# UNITED STATES PATENT AND TRADEMARK OFFICE

10/091,432

Shigetaka Asano

<b>Office Action Summary</b>	<b>Application No.</b> 10/091,432	<b>Applicant(s)</b> ASANO, SHIGETAKA	
	<b>Examiner</b> Qutub Ghulamali	<b>Art Unit</b> 2611

Fig. 4

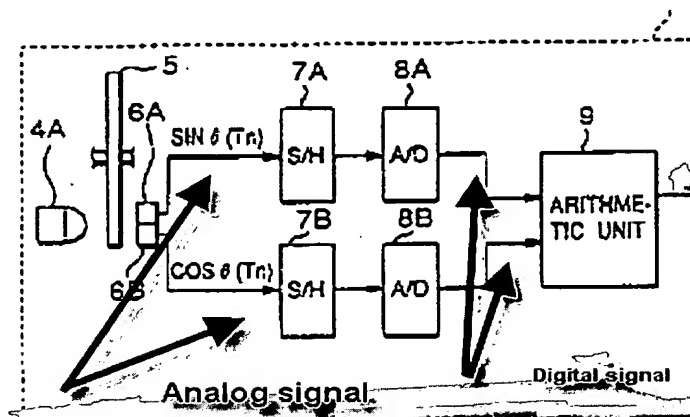
The examiner response – The examiner disagrees and respectfully would like to draw applicant's attention to Tsutsumishita, wherein Tsutsumishita discloses an analog control method comprising:

converting the analog signal to a digital signal via a first path (figs. 1, 2, 4; col. 12, lines 22-31);

performing an arithmetic processing of the digital signal via the first path to generate a control signal for controlling the analog signal (col. 7, lines 1-28; col. 12, lines 22-26).

The Tsutsumishita reference however, does not explicitly disclose a second path with a delay for delaying the analog signal.

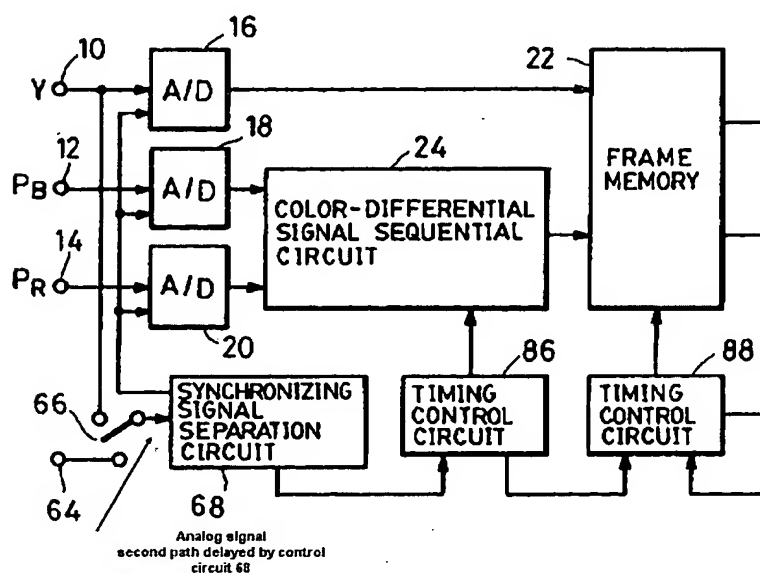
What Tsutsumishita does not explicitly disclose is delaying the analog signal corresponding to a latency caused by the generation of the control signal to generate a delayed analog signal in a second path that is different from the first path. This feature is satisfied by Kashida, as Kashida discloses a second path with a delay element (timing control with delay, element 86) delaying the analog signal corresponding to a latency caused by the generation of the control signal to generate a delayed analog signal in a second path that is different from the first path (the A/D path) (col. 5, lines 7-24; col. 6, lines 39-46) and controlling the delayed analog signal in accordance with the control signal in the second path. It would have been obvious to a person of ordinary

skill in the art at the time the invention was made to use a delay circuit to delay analog signal in a second path in the analog control circuit with control as taught by Kashida in the circuit of Tsutsumishita because by providing the delay that is equivalent to the ADC latency can mitigate time differences in the analog signal processing corresponding to the latency of the ADCs.
